Traffic Signal Supplementary Report (TSSR) – AMD Scheme Design and Impact Assessment

Document No: SQA-0569 - issue: 2

Title:	Cycle Enfield – A105 Corridor Scheme		
Location (Area):			
Borough:	Enfield	Road Network (TLRN, SRN, Other):	SRN
Road Number / Corridor:	A105	WBS Code:	SC.3230.132
Funding:	TfL Cycling Programme - Mini-Holland Scheme	Highway Authority:	London Borough of Enfield
Objective:	This corridor forms part of the Mayor’s Cycle Enfield Mini-Holland programme, which is looking to deliver transformational change for cycling across the borough. This includes segregated cycle facilities, in the form of light segregation, or tracks along the links and segregated cycle facilities at signalised junctions.		
Scheme Details:	<p>The proposed junctions have features including</p> <ul style="list-style-type: none"> • Separate cycle phases, either on-carriageway, or on footway, in one instance. • Early-release • 2-stage right turns • Advanced stop lines <p>Cyclists are protected through timing/movement separation. Details of the proposed layouts and designs can be found in the reports and other information listed in the ‘Information Supplied’ section.</p>

The existing bus routing is shown in the figure below.

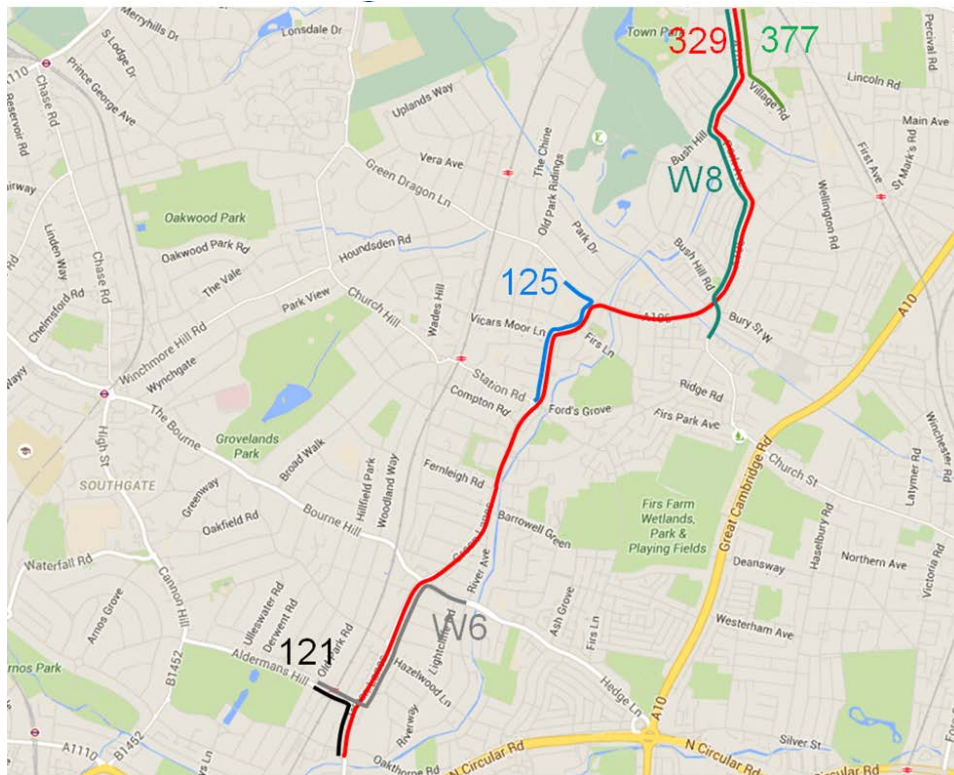
- There is an increased margin of error in the delay results calculated by LinSig at junctions where DoS is above 90%. This is applicable in the proposed scenario at every junction apart from 32/011 (Green Lanes/Alderman's Hill).
- The absolute change in delay value as represented in the results table cannot be guaranteed to a high degree of accuracy.
- Results are not as accurate as if VISSIM modelling had been carried out (however a VISSIM model of this network would have been very difficult to validate given the large distances between signalised junctions).

The table below shows the difference in journey time per route, by direction and peak hour.
